ADDENDUM NO. 3

Issue Date:	September 11, 2020
Project Name:	Interior Renovation of the Indian River County Building and Fire Departments
Bid Number:	2020057
Bid Opening Date:	September 23, 2020

This addendum is being released to answer questions received to date, provide the pre-bid minutes, and to modify the plans.

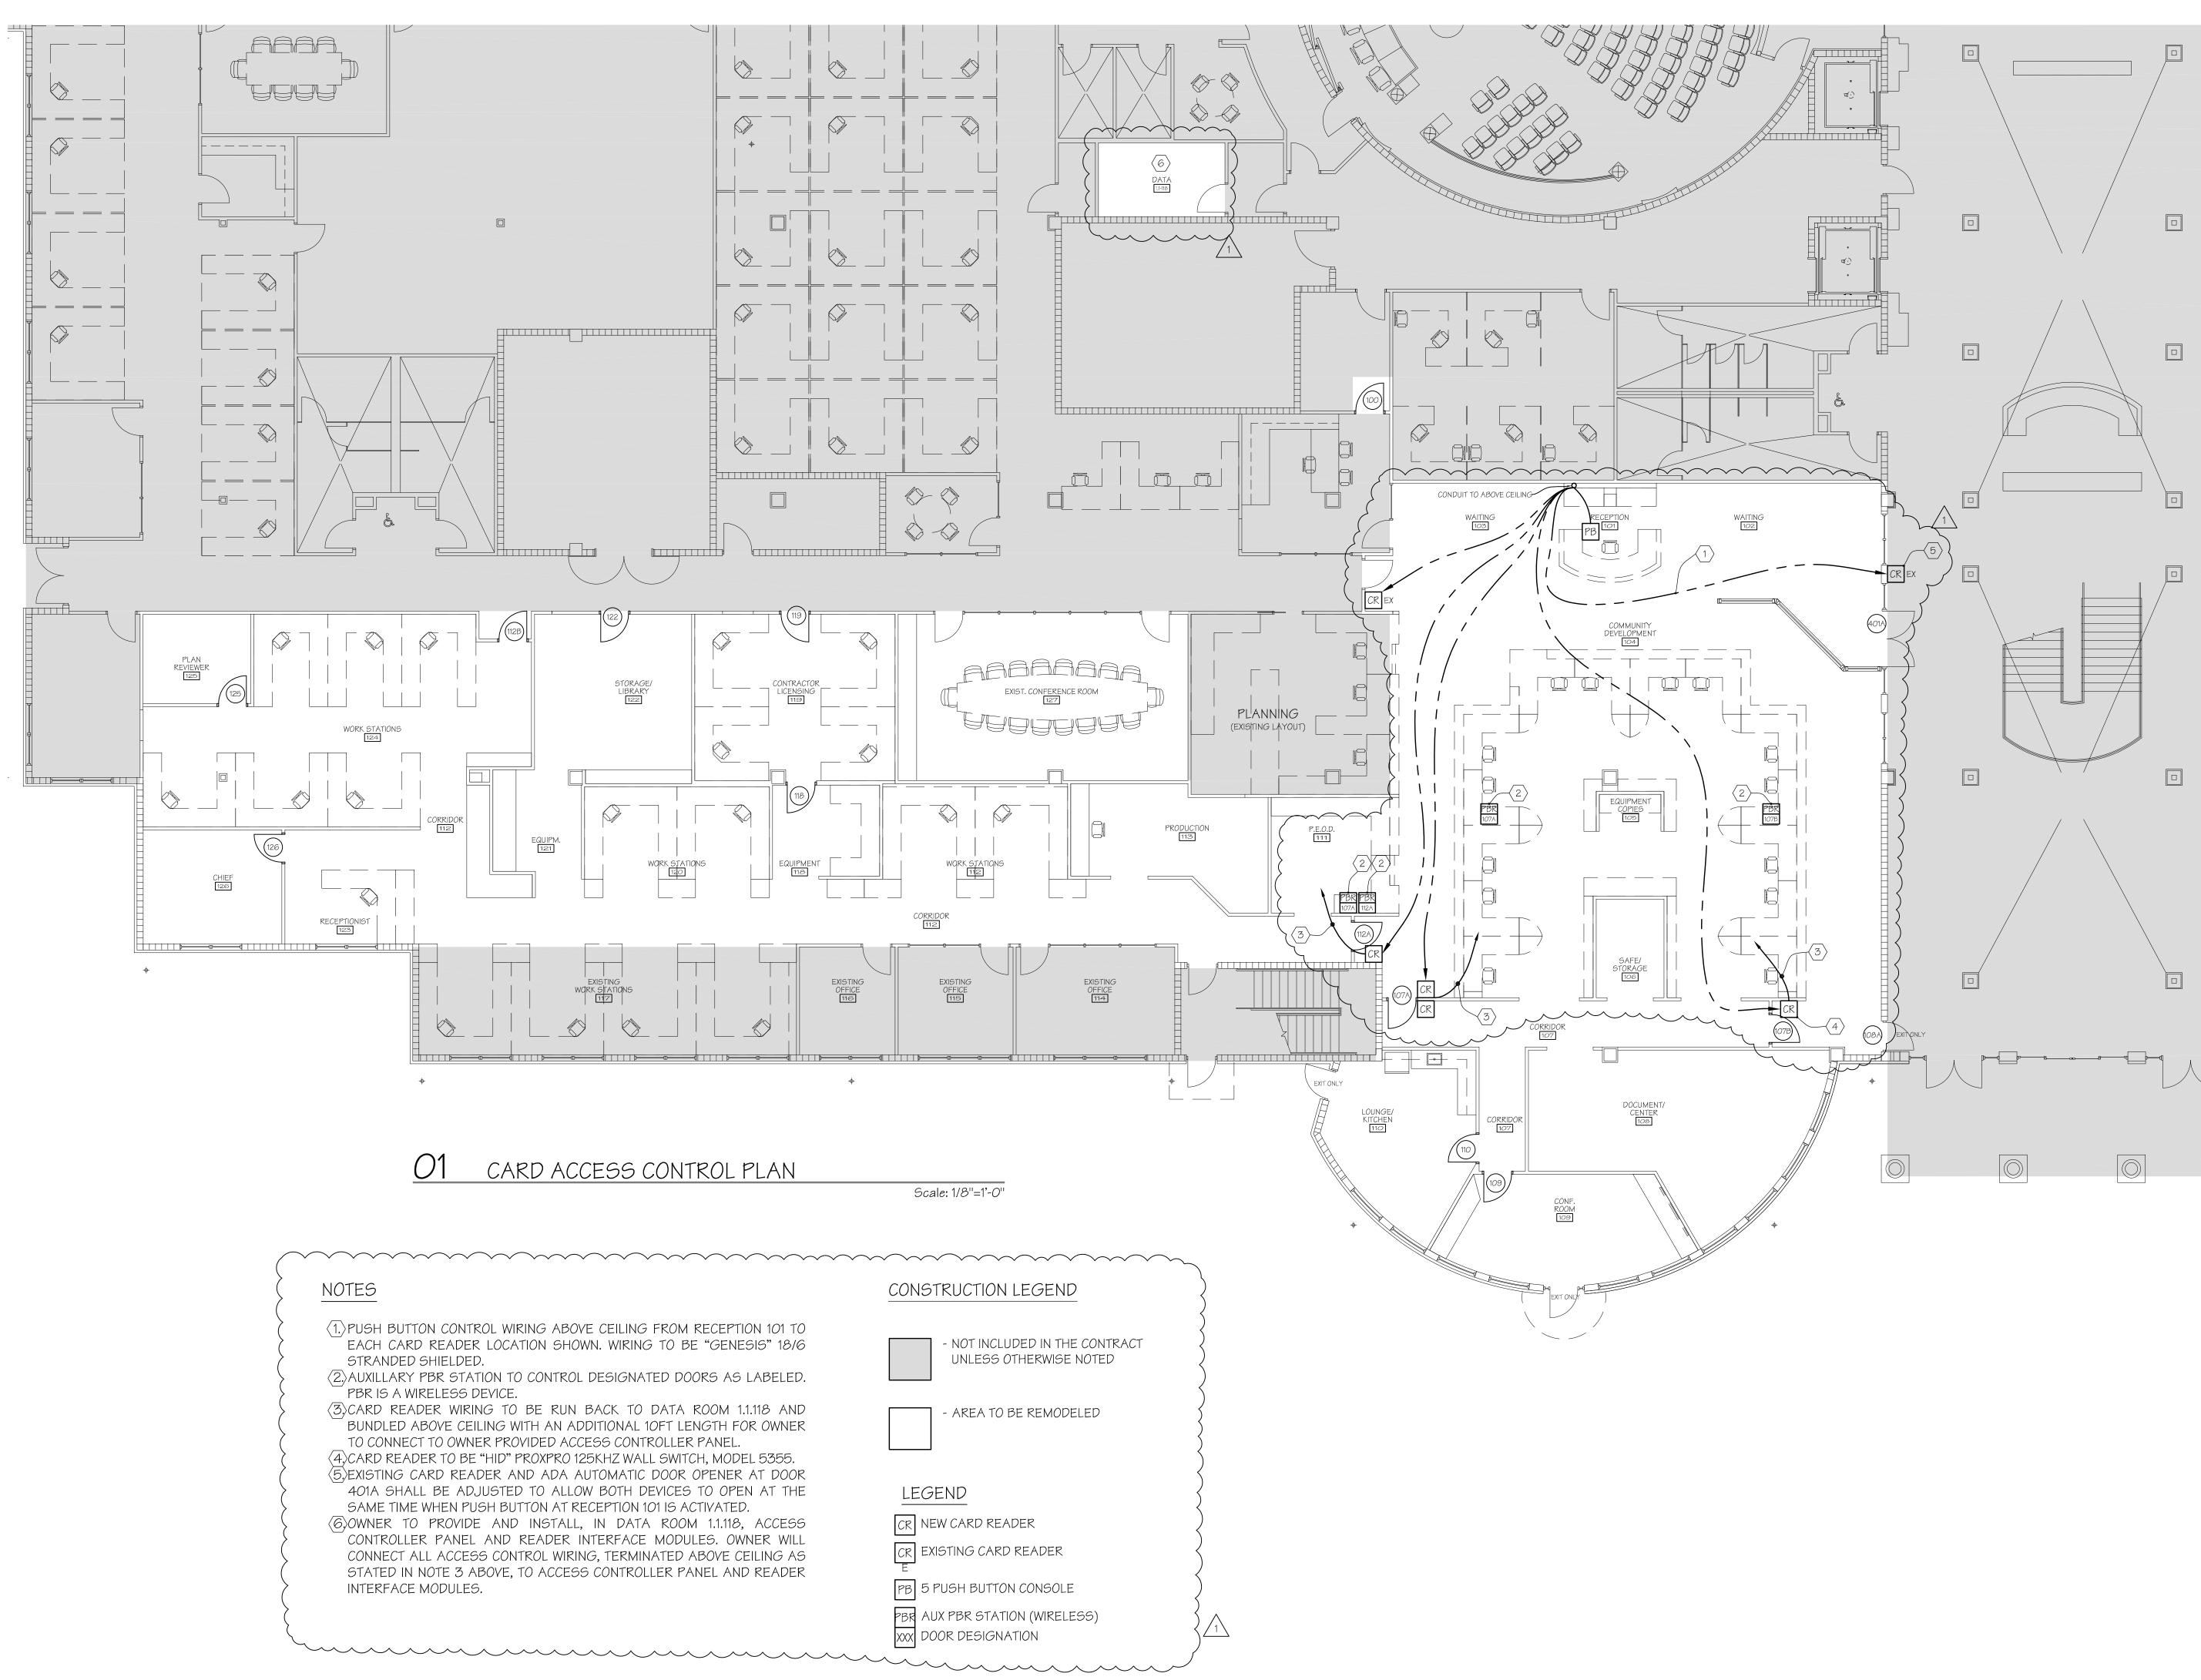
Modifications to Bid Documents: Replace Drawing A2.13 with attached A2.13 dated September 11, 2020
